TOWN OF MILFORD, NH  
OFFICE OF COMMUNITY DEVELOPMENT

**Date:** August 10, 2022  
**To:** Planning Board  
**From:** Lincoln Daley, Community Development Director  
**Subject:** SP2022-05 30 Wilton Road LLC for the property located at Tax Map 6, Lot 14, 30 Wilton Road. Public Hearing for a Conditional Use Permit/Major Site Plan Application to construct 3 story, 40 foot tall, 13,950 square foot (41,850 square foot gross floor area) self-storage facility and associated, parking, site and drainage improvements in the Integrated Commercial Industrial zoning District and West Elm Overlay. (*Continued from 7/21/22*)

PROJECT:  
**STORAGE SENSE - MILFORD WEST**

TITLE:  
**GRADING AND DRAINAGE PLAN**

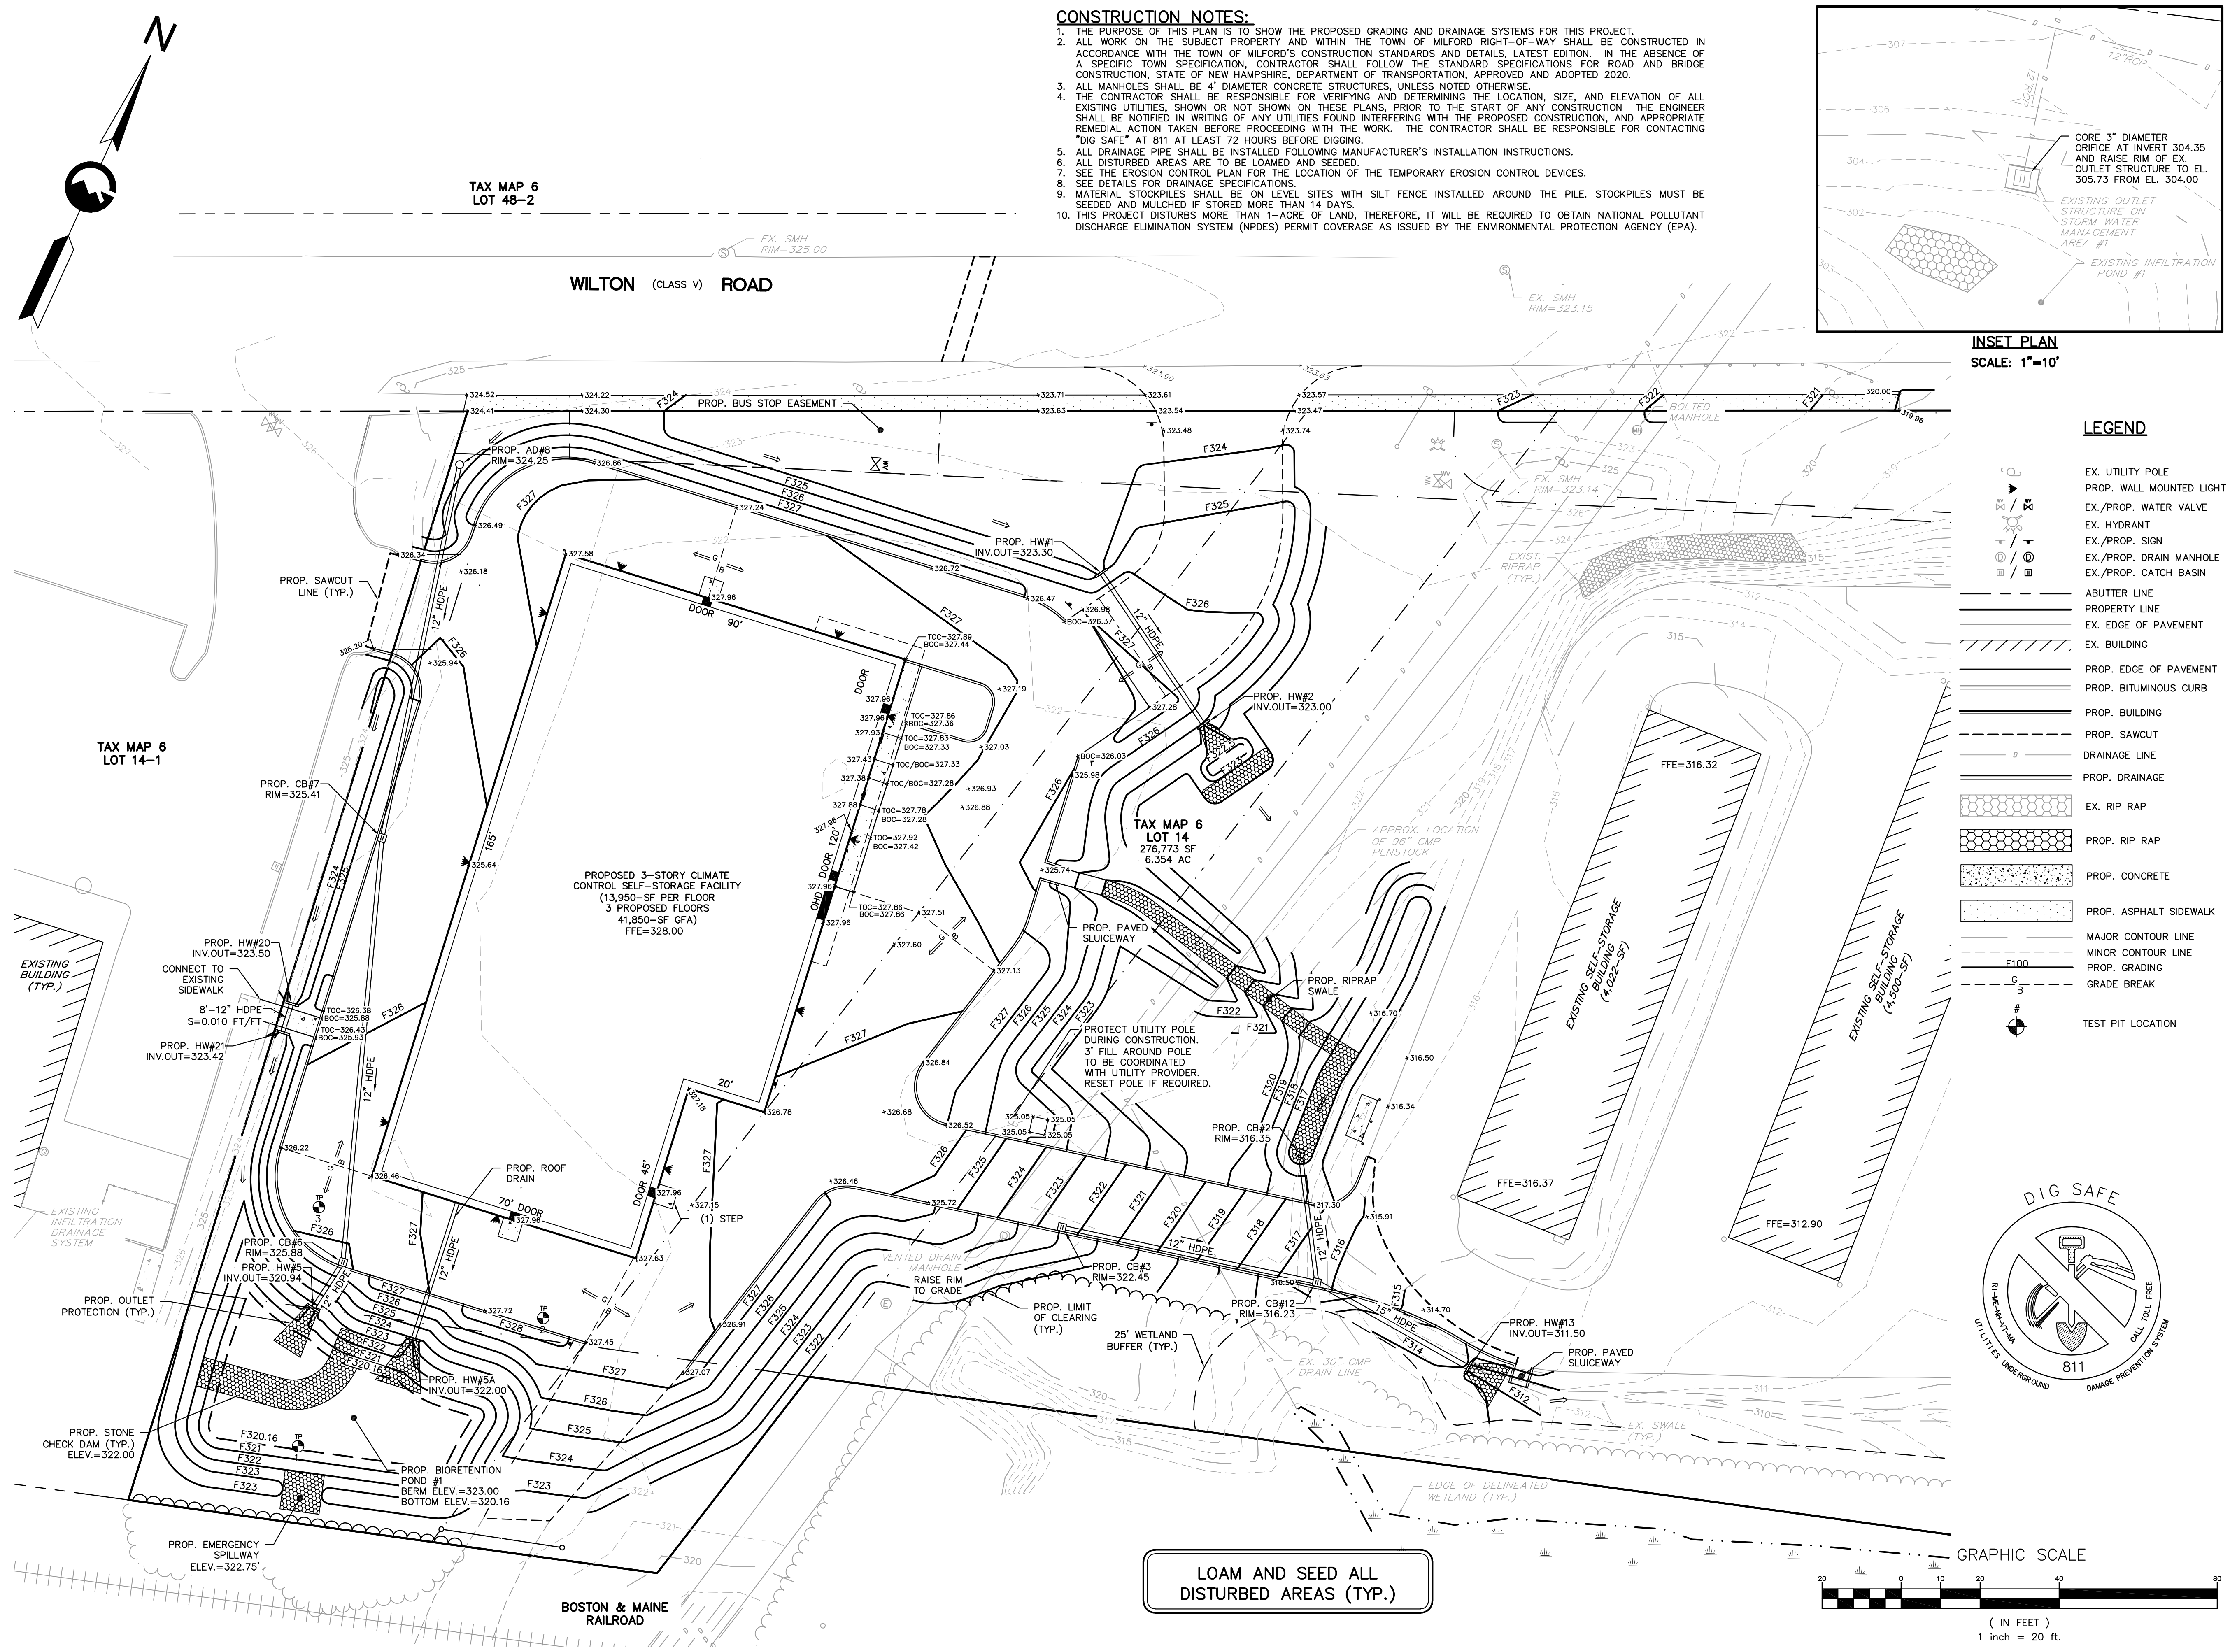
4. Sheets 1, 4-7. Please revise the plans accordingly to include the location of the underground penstock.

**The HydroCAD analysis has been revised in both pre- and post-construction conditions to match the existing conditions plan with regards to inverts and basin dimensions. Additionally, the plans proposed a change to the rim elevation of the outlet structure and the coring of a new orifice at the outlet control structure of Existing Infiltration Basin #1, see Sheets #1 & #5.**

TITLE:  
**LIGHTING PLAN**

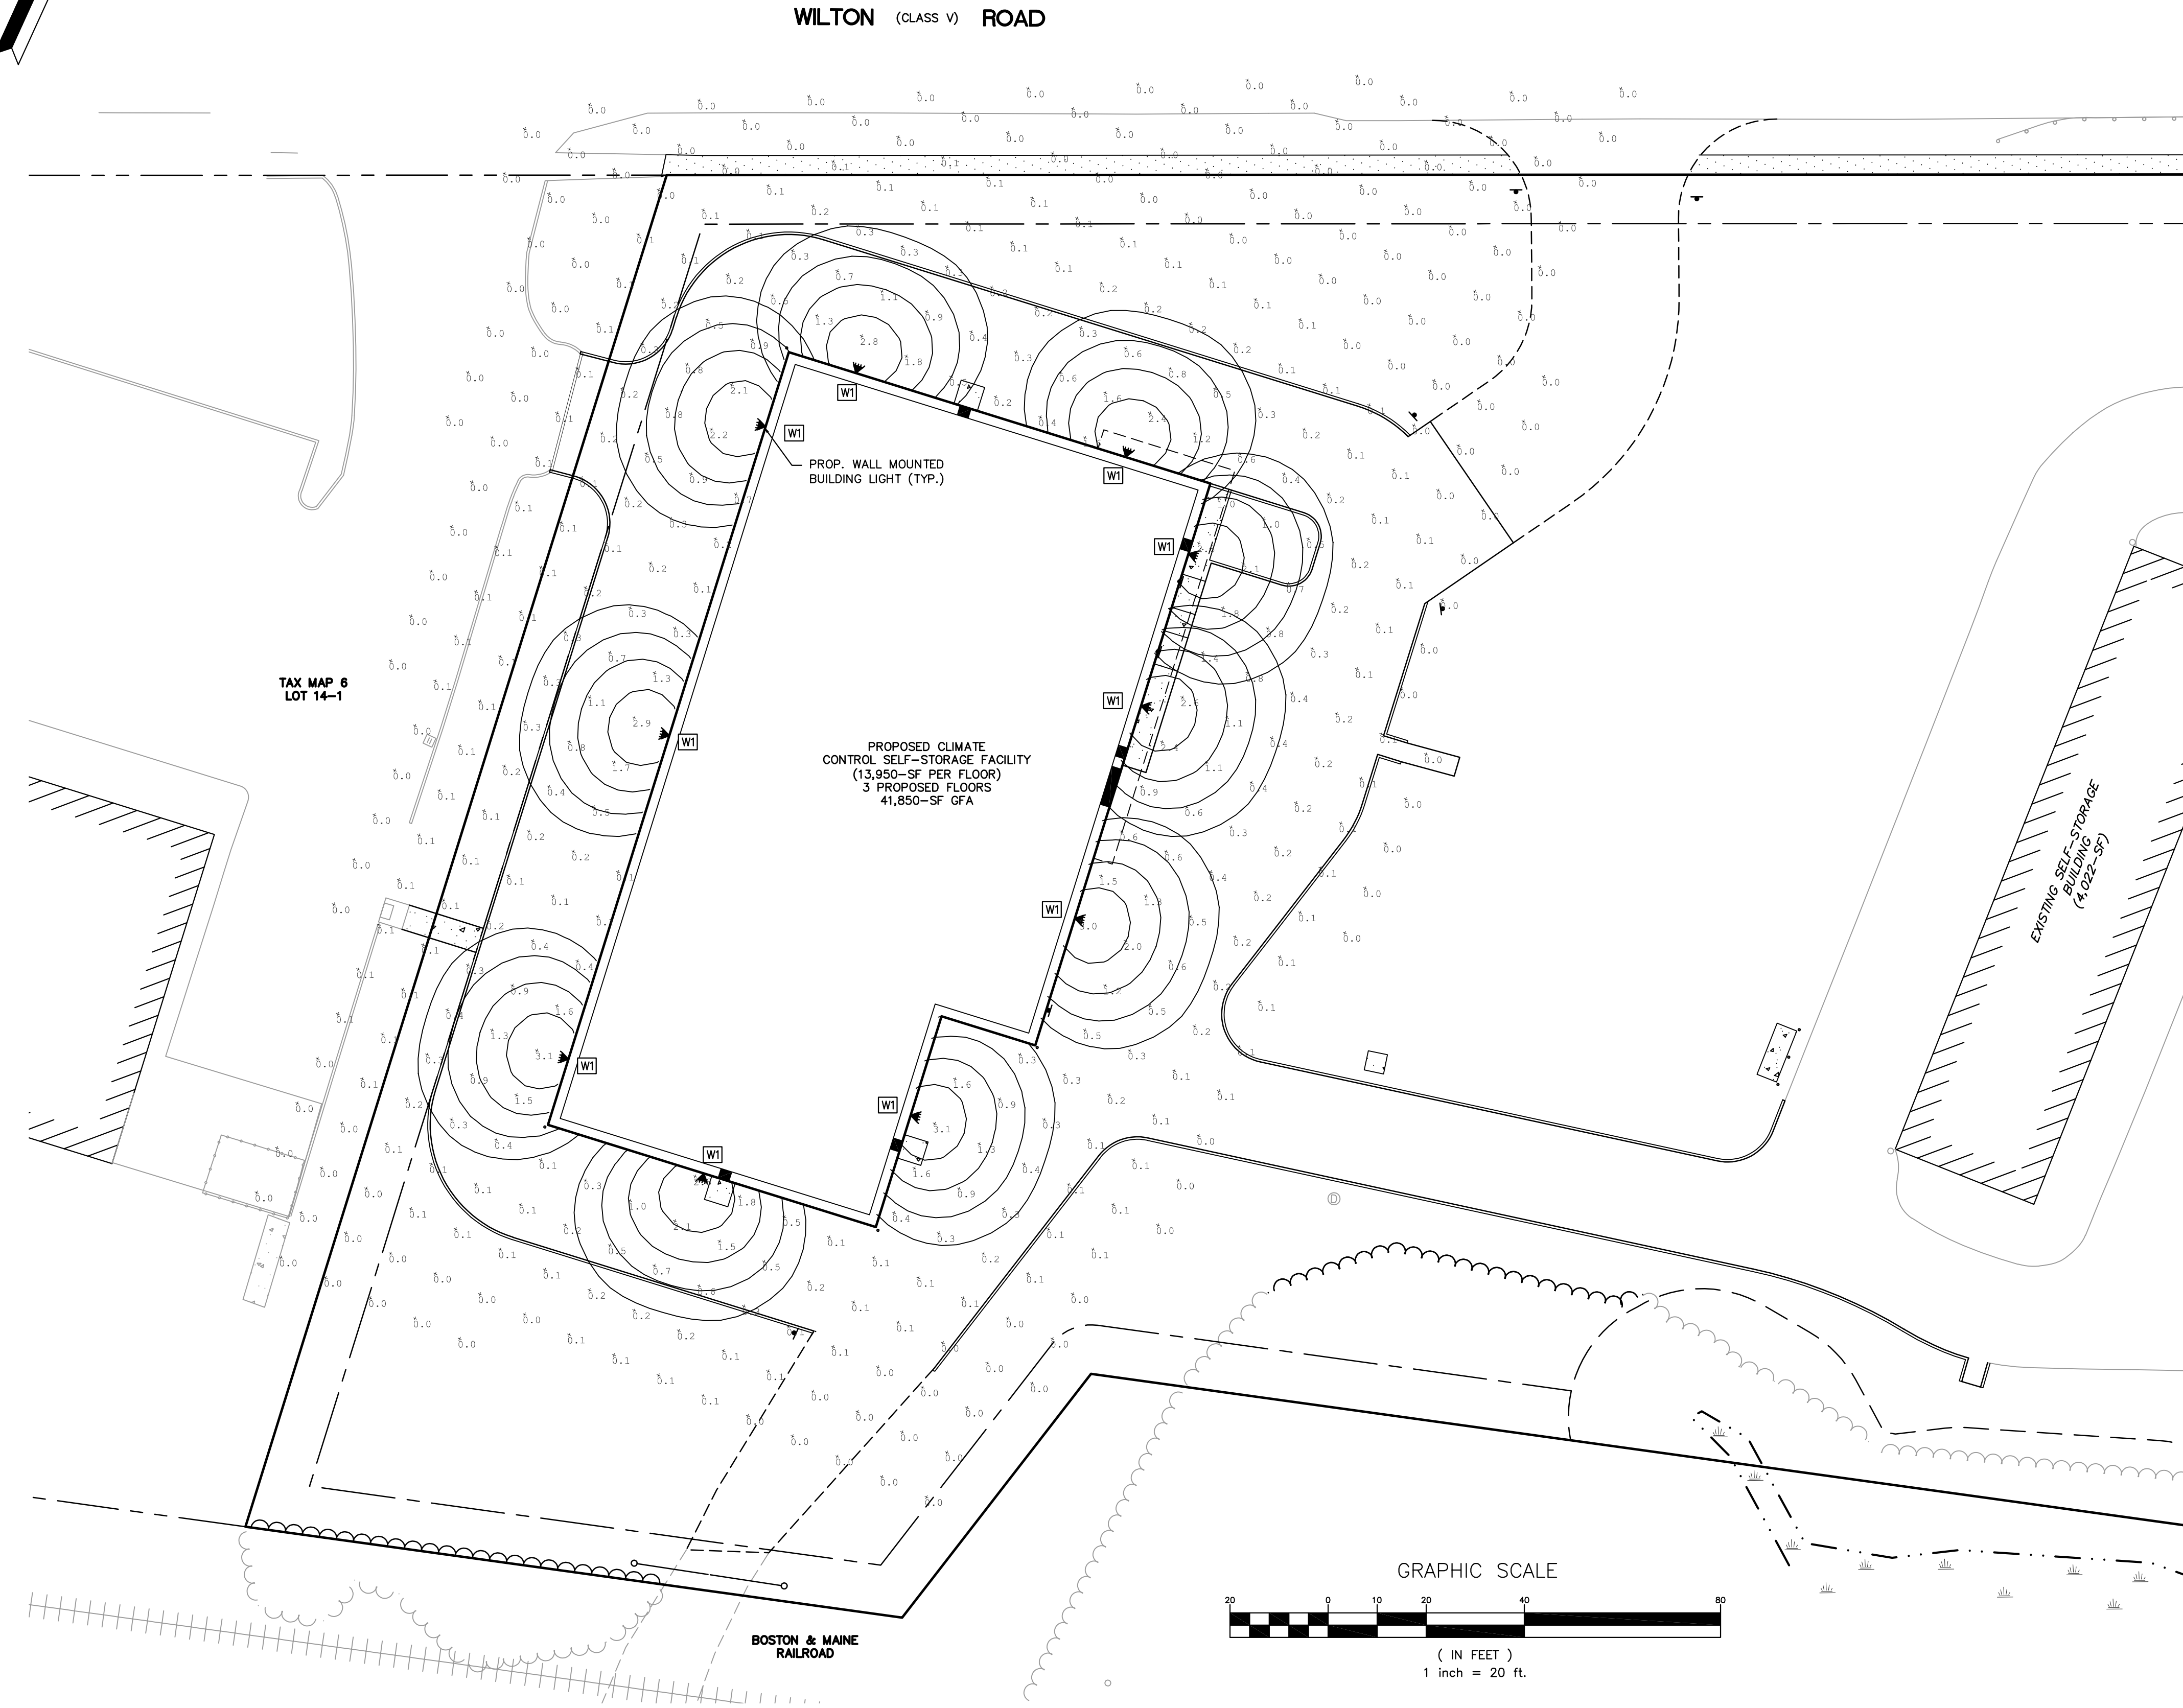
6. Sheet 8. Please revise the plan set to include the engineering and construction details for the lights. Include the manufacturing photographs of each proposed light. *Comment Addressed – See 8/9/22 Response Letter*

7. Sheet 8. Please revise the plan set to include the engineering and construction details for the lights. Include the manufacturing photographs of each proposed light.

**Plans have been updated, see Sheet 9.**
